ARCHITECTURAL ACCESS BOARD - HEARING PACKET

Name **New England Sports Center**
Address **121 Donald Lynch Blvd.**
City **Marlborough, MA 01752**

Site Visit Report

RE: New England Sports Center, 121 Donald Lynch Blvd, Marlborough (C24-002)

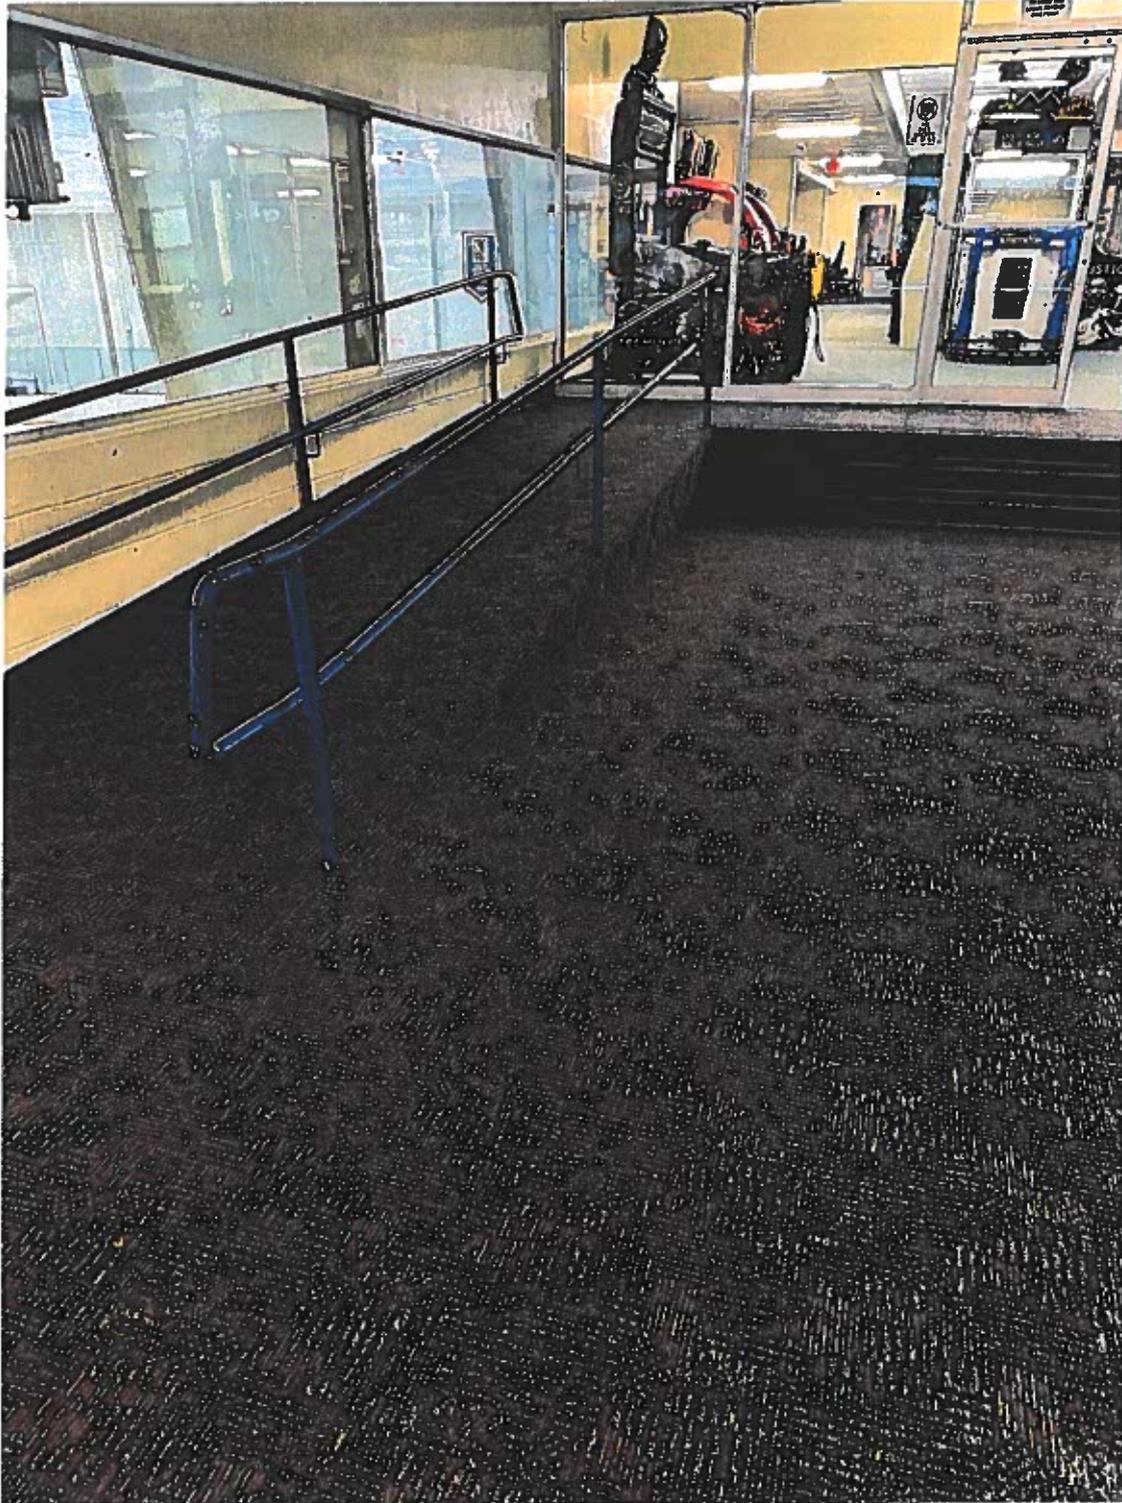
24.2 exceeds 8.3%
